AGENDA

MATANUSKA-SUSITNA BOROUGH

ABBREVIATED PLAT AGENDA
ASSEMBLY CHAMBERS
350 EAST DAHLIA AVENUE, PALMER

February 12, 2025

A PLAT OF
SHERWOOD FOREST

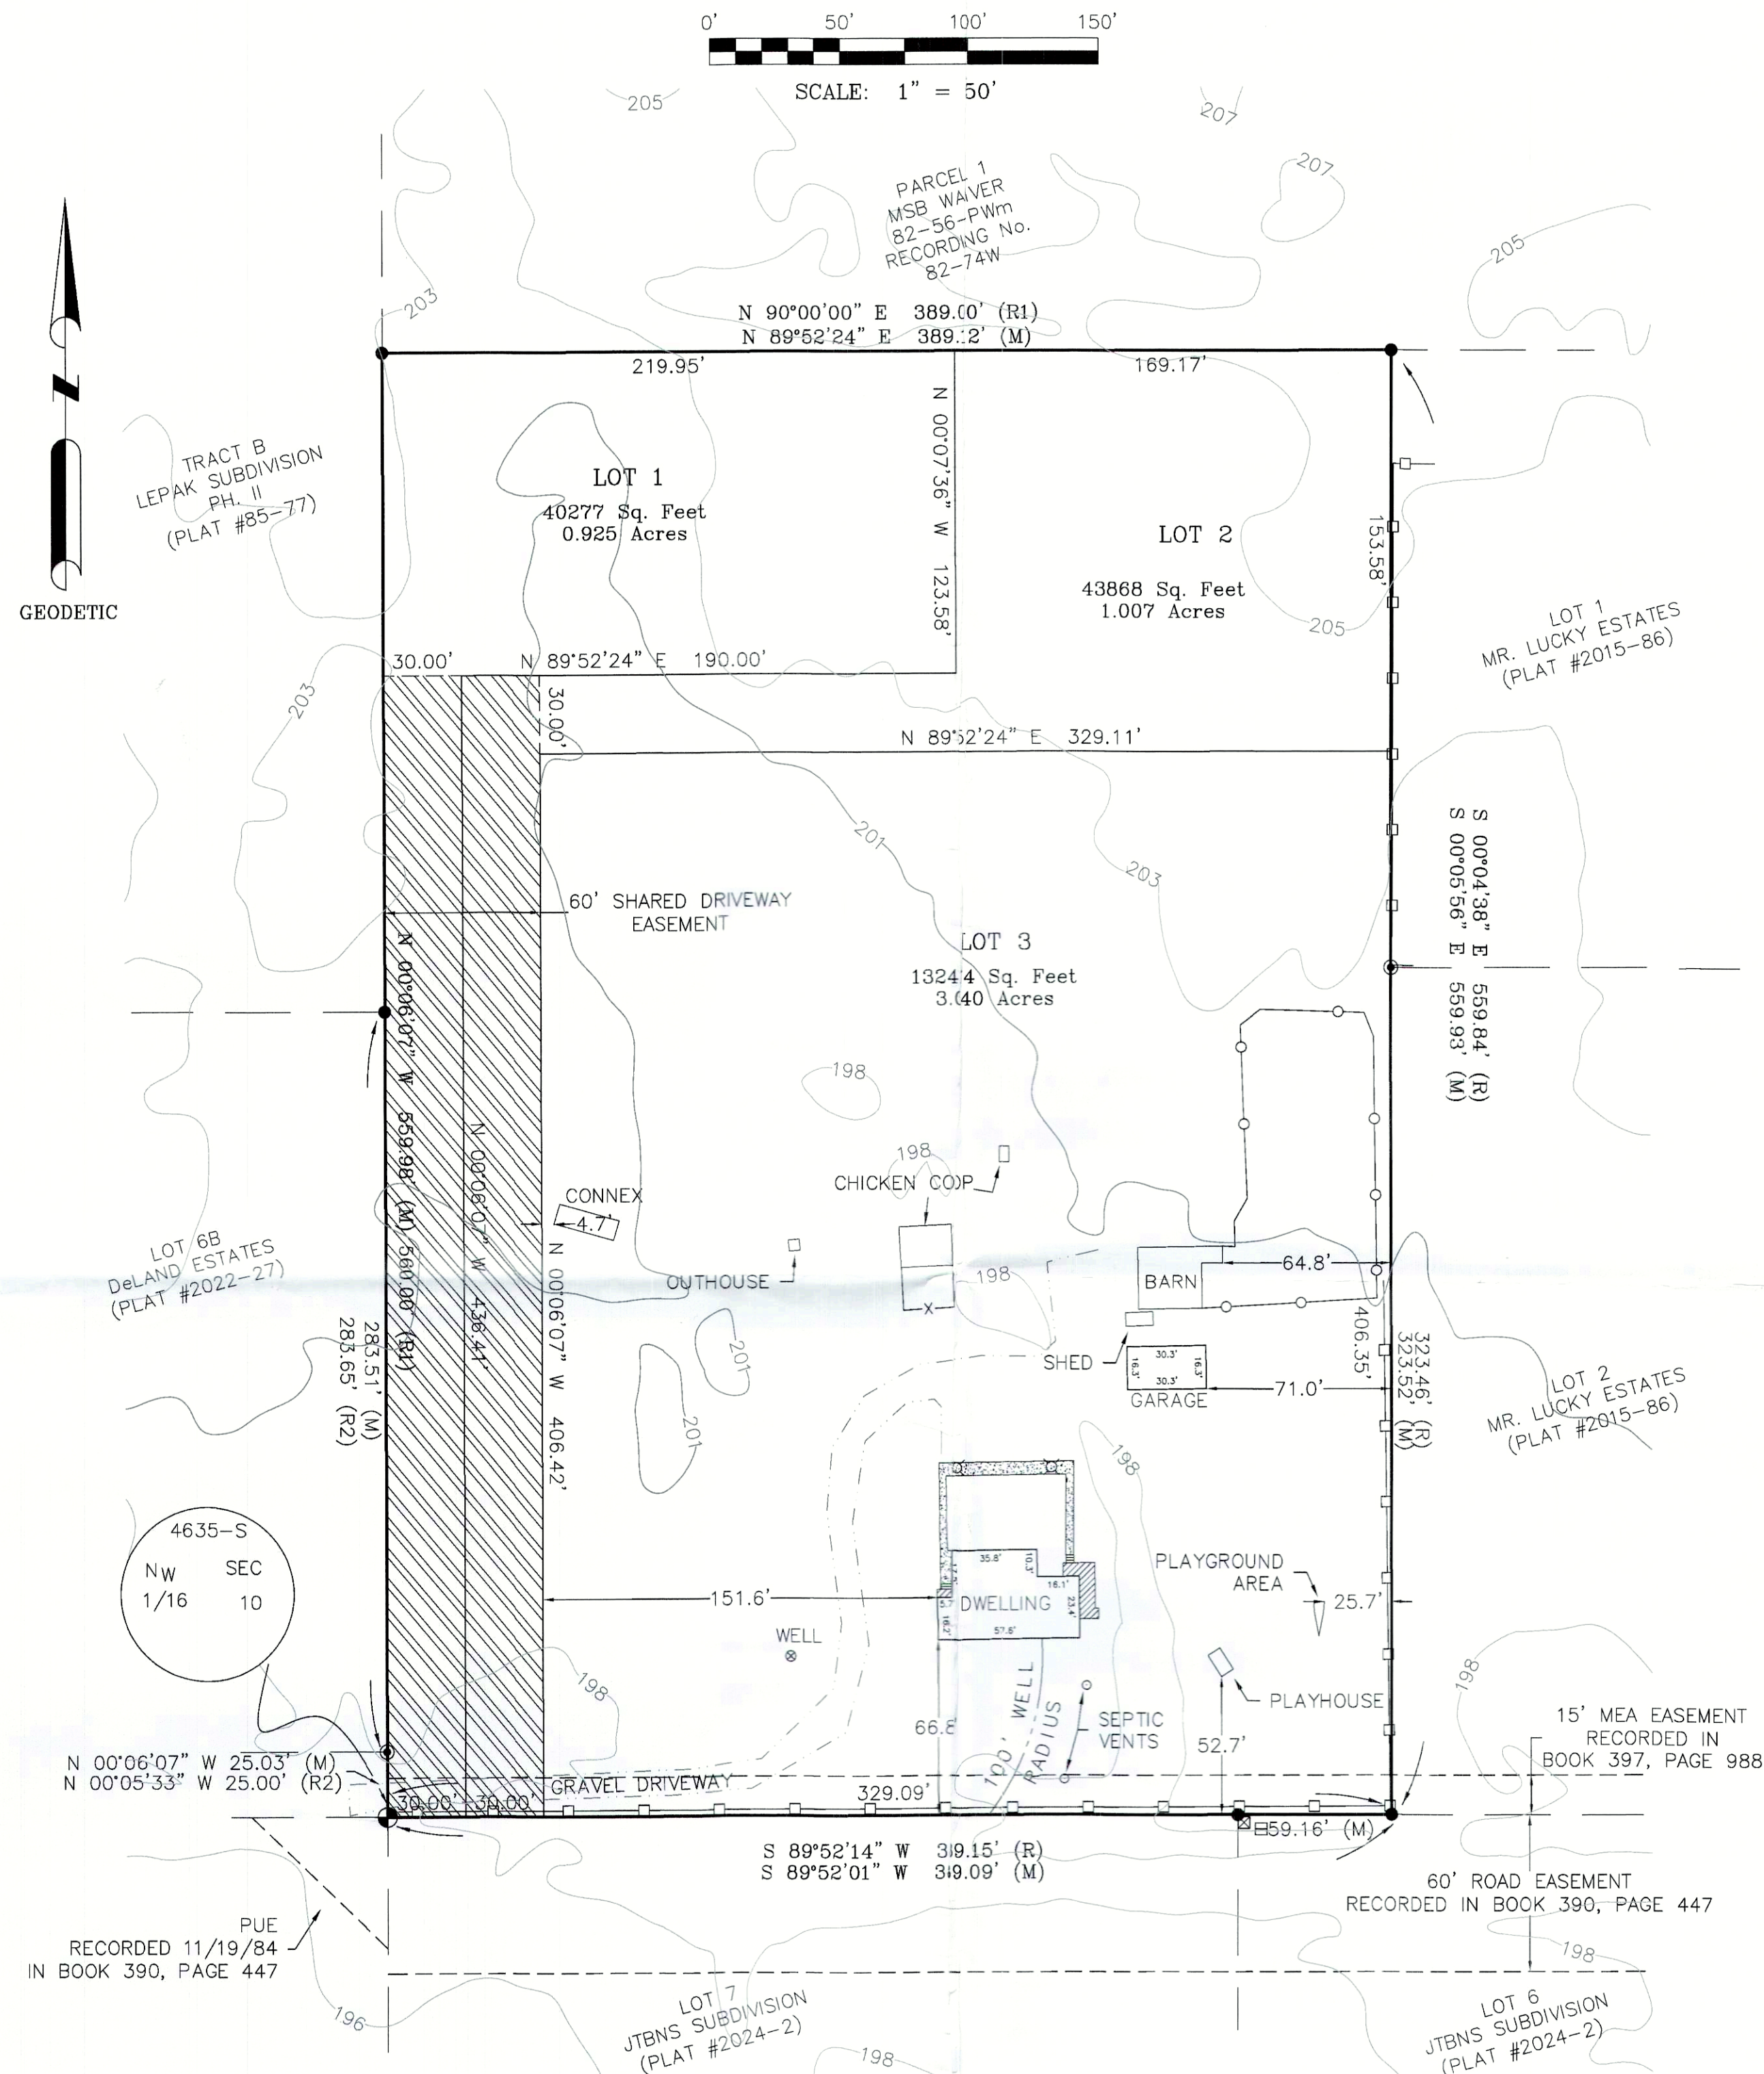
Department of Public Works (**Exhibit C**) notes the existing non-conforming driveway should be removed. (**Recommendation #4**)

A condition of approval of the subdivision should be made to remove the existing non-conforming driveway (driveway permit 31382).

3. Pay postage and advertising fees.
4. Remove the non-conforming driveway on the southwest corner of the parent parcel. Provide platting staff proof of the removal.

5. Provide platting staff proof that no setback violations will be created by this platting action.
6. Increases the pole portion width of Lot 2 to 40' for the portion that is separate from Lot 1's pole portion.

7. Grant a common access easement overlaying the side by side flag pole portions.
8. Show all easements of record on final plat.
9. Submit recording fees, payable to Department of Natural Resources (DNR).

JOB NO. 24-161 DATE: 12/10/2024 DWN: HW CHK: WW
SCALE: 1" = 60' FB: 289 PG: 32 SHEET 1 OF 1

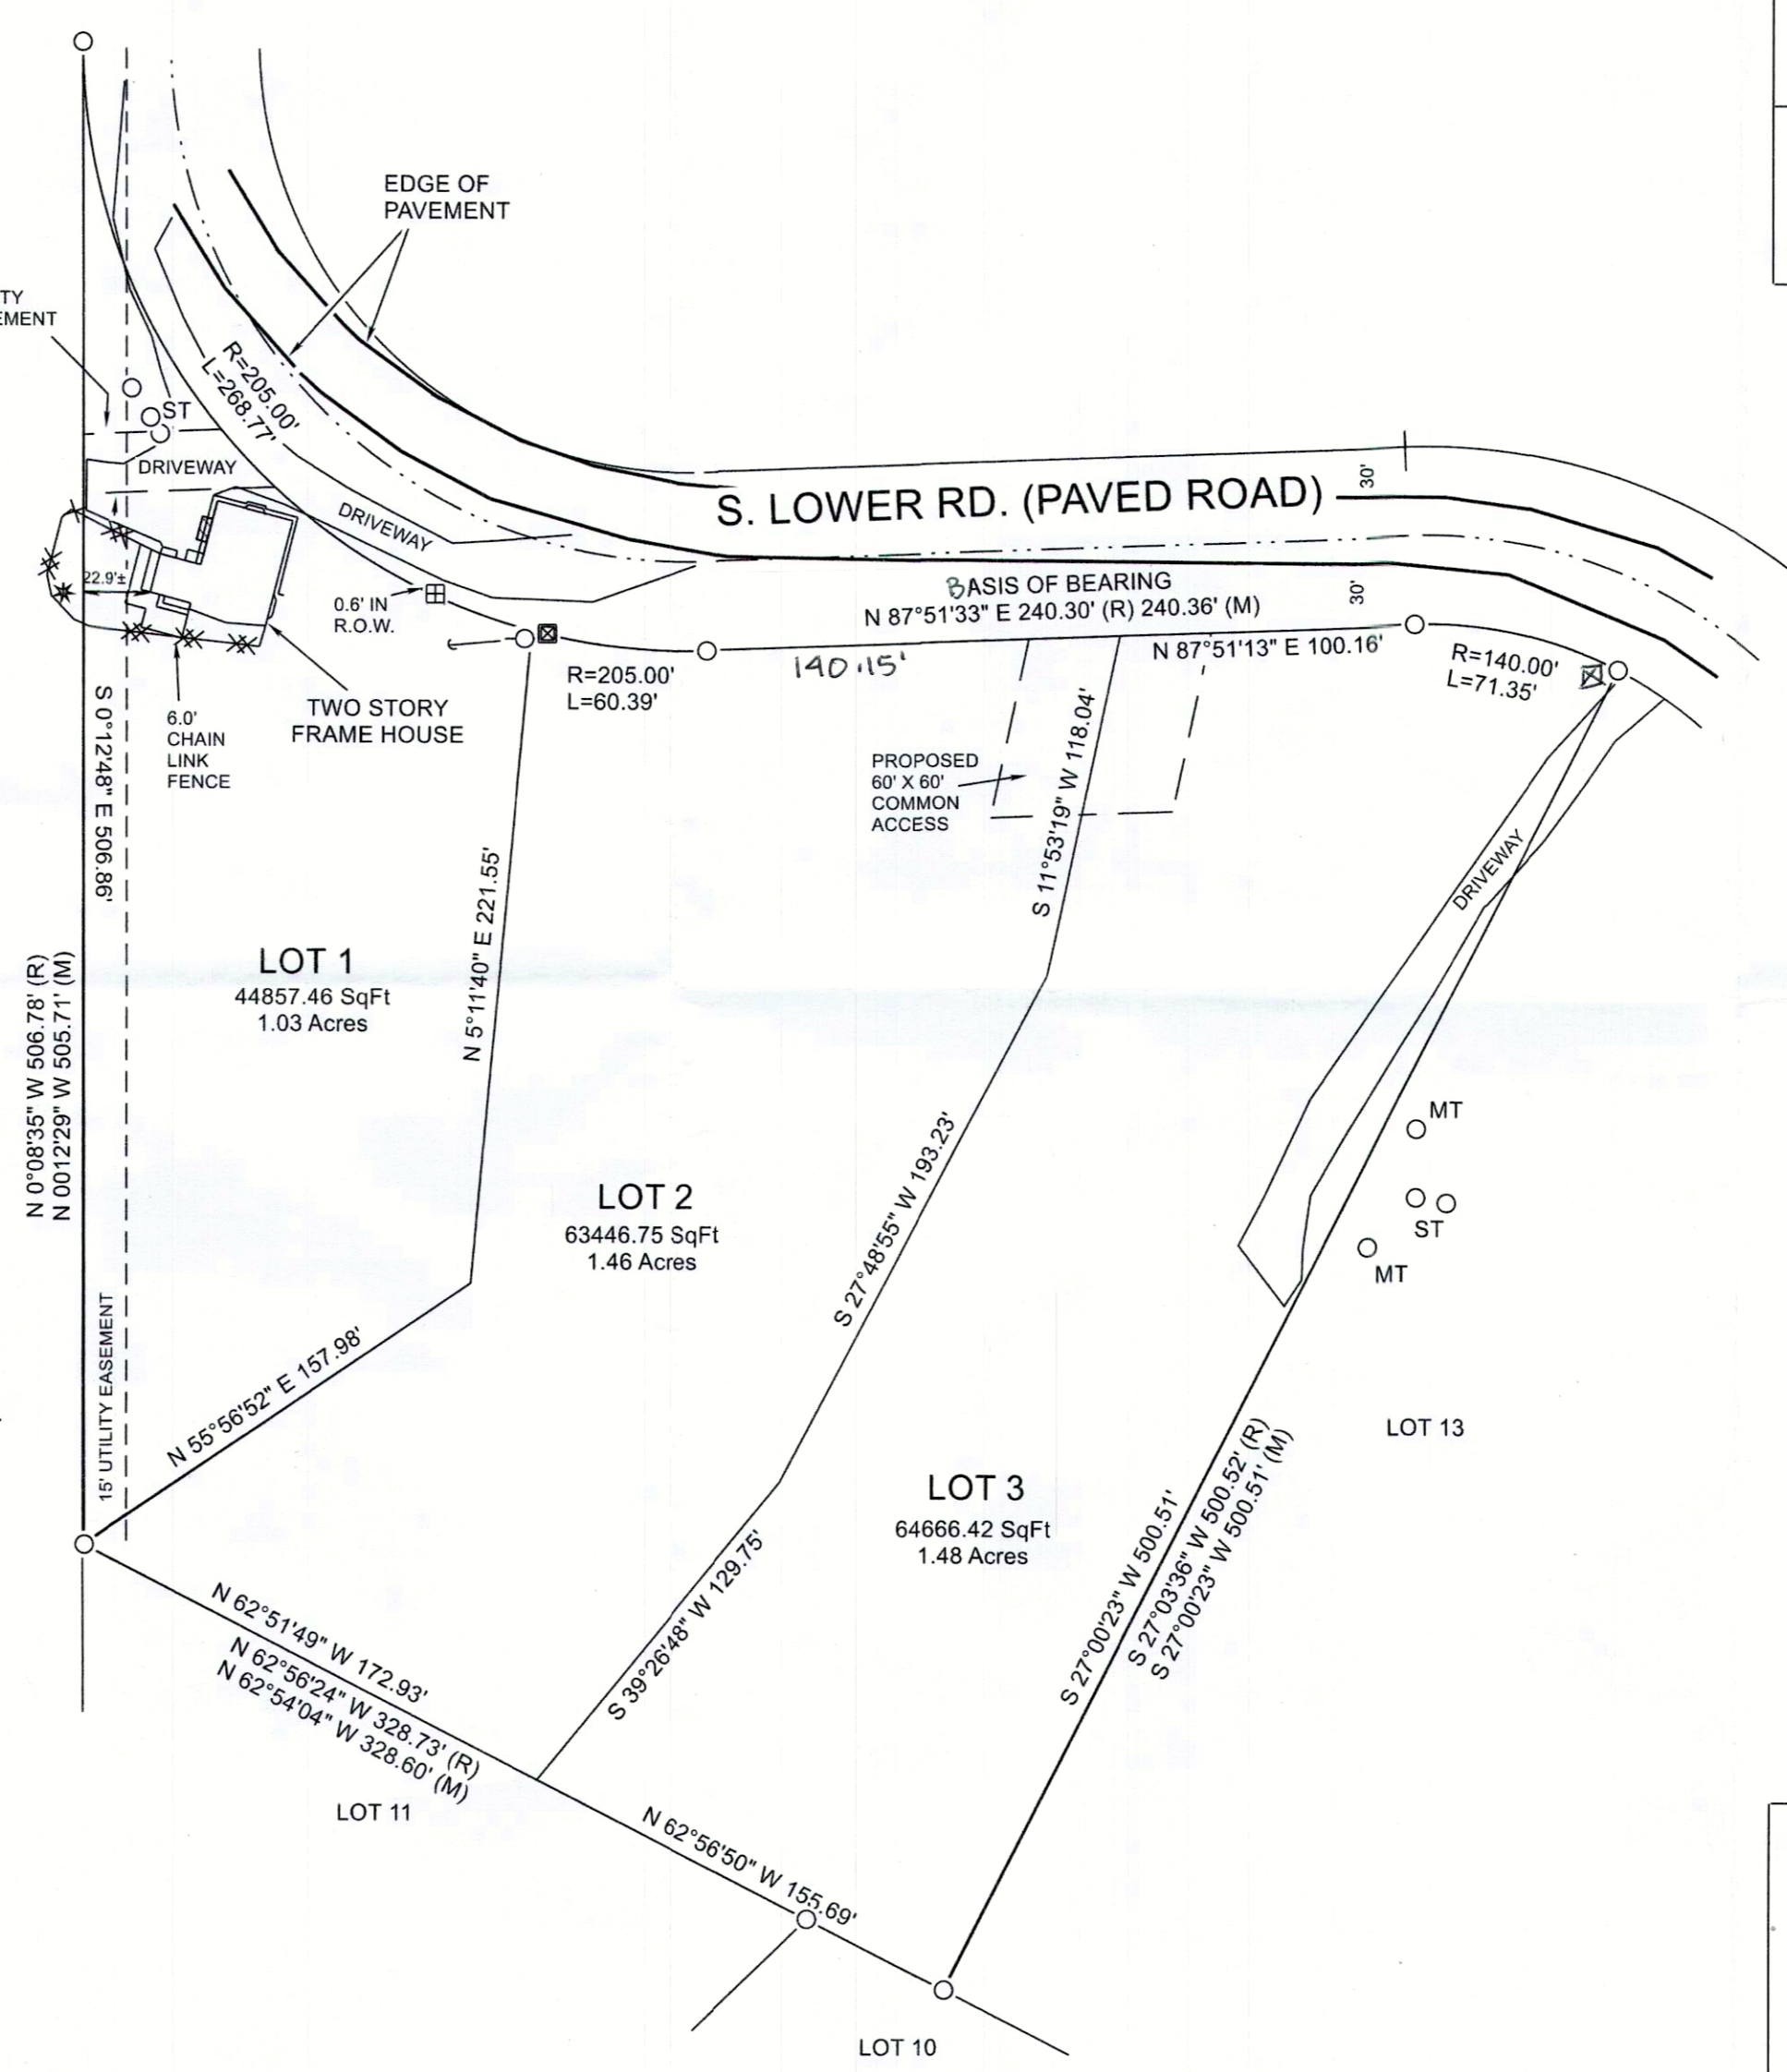
Comments: Department of Public Works (**Exhibit D**) notes, “ The petitioner should provide an additional test hole in south western portion of the subdivision to display how the soil and ground water table here meet the code requirements of Title 43.20.281. It appears that areas with steeper than 25% grade are being currently included as useable septic area. Remove these areas from the useable septic area in the report.”

The petitioner should provide an additional test hole in south western portion of the subdivision to display how the soil and ground water table here meet the code requirements of Title 43.20.281. It appears that areas with steeper than 25% grade are being currently included as useable septic area. Remove these areas from the useable septic area in the report.

3. Petitioner will provide updated soils log with an additional test hole in the south western portion of the subdivision Pursuant to 43.20.281; and revise the usable area calculations with the areas of grade over 25% not included in the usable septic area calculations.

4. Apply for driveway permit for existing driveway and provide staff with a copy of the application.
5. Pay postage and advertising fees.
6. Show all easements of record on final plat.
